SPECIAL SERVICE WEWS

H1 CYLINDER EXHAUST FLANGE STUD BULLETIN #H-2 January 14, 1970

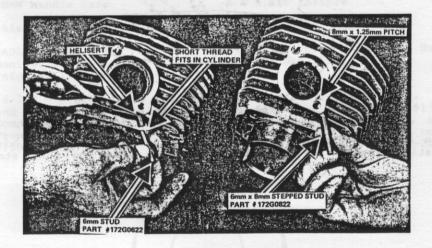
SUBJECT: To improve servicing, the cylinder exhaust flange stud has been changed from a plain 6mm stud to a stepped 6mm x 8mm stud. The difference in parts is shown below.

APPLICATION: The 6mm x 8mm stud was incorporated on H1's after Engine #03138.

- A. H1's BEFORE ENGINE #03138. The original cylinders on these units have helical thread inserts. If a flange stud breaks, you must use the early 6mm stud for replacement. NOTE: The 8mm stud cannot be used in the early cylinders because the hole is a 1.0mm pitch thread, while the stud is a 1.25mm pitch thread.
- B. H1's AFTER ENGINE #03138. The later 6mm x 8mm stud must be used for replacement in these cylinders.

PARTS SUPPLY: Both early and late studs are available. New Hr cylinders shipped from Parts Department are packaged with two 8mm studs.
